APPLICATION NO.	FILING DATE	FIRST NAMED INVENTOR	ATTORNEY DOCKET NO.	CONFIRMATION NO.
10/686,063	10/15/2003	Gene P. DiPoto	ENDIUS.027CP1D1	7977
	7590	EXAMINER		
1221 NICOLLET AVENUE SUITE 800 MINNEAPOLIS, MN 55403-2420			BUI, VY Q	
			ART UNIT	PAPER NUMBER
			3773	
			MAIL DATE	DELIVERY MODE
			02/20/2009	PAPER

Application No.	Applicant(s)			
	10/686,063	DIPOTO ET AL.			
Office Action Summary	Examiner	Art Unit			
	Vy Q. Bui	3773			
The MAILING DATE of this communication app Period for Reply	pears on the cover sheet with the c	orrespondence address			
A SHORTENED STATUTORY PERIOD FOR REPL WHICHEVER IS LONGER, FROM THE MAILING D - Extensions of time may be available under the provisions of 37 CFR 1.1 after SIX (6) MONTHS from the mailing date of this communication. - If NO period for reply is specified above, the maximum statutory period - Failure to reply within the set or extended period for reply will, by statute Any reply received by the Office later than three months after the mailing earned patent term adjustment. See 37 CFR 1.704(b).	ATE OF THIS COMMUNICATION 36(a). In no event, however, may a reply be tin will apply and will expire SIX (6) MONTHS from a, cause the applicatio

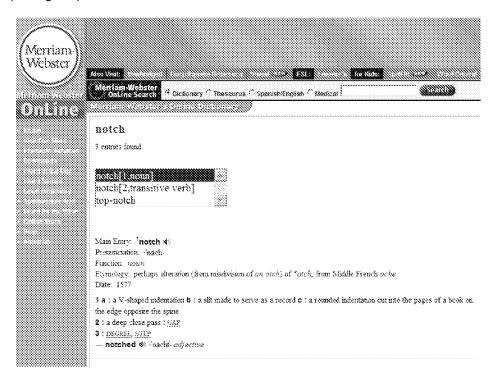
3. Argument: Independent claim 87 further recites, in part, "wherein the discrete segments are moved away from each other by being guided incrementally along successive notches of a guiding mechanism." Claim 96 recites, "wherein each of said notches maintains a desired configuration of said retractor," claim 97 recites, "wherein each of said notches prevents the retractor from moving from an expanded configuration to a contracted configuration," and claim 98 recites, wherein the guiding mechanism comprises at least three notches." Kogasaka et al. do not appear to teach or suggest these. The Examiner asserts that "notches" are

interpreted as different steps or degrees of expanding of discrete segments 444. Applicants respectfully disagree. Kogasaka et al. do not appear to teach or suggest notches or a guiding mechanism, other than the tube 447, which does not appear to have notches or any other structure that would be expected to allow the segments 444 to move away from each other incrementally. The Examiner has not provided any reasoning for the interpretation of "notches of a guiding mechanism" on the structure or Kogasaka et al. Further, the Examiner has not provided any reasoning for why one of ordinary skill in the art would interpret the method steps of Kogasaka et al. as including the claimed method step. Kogasaka et al. thus do not appear to teach the identical method steps in the same detail as is recited in claims 87 and 96-98.

Response: a notch, by definition, can be broadly understood as a step, a degree (see definition 3 of "notch" copied and shown on next page, Merriam-Webster Dictionary). Spring member 444 and mesh 443 expand step by step when handling rod 447 is pulled proximally. Each "pulling step" defines a notch as recited in the claims.
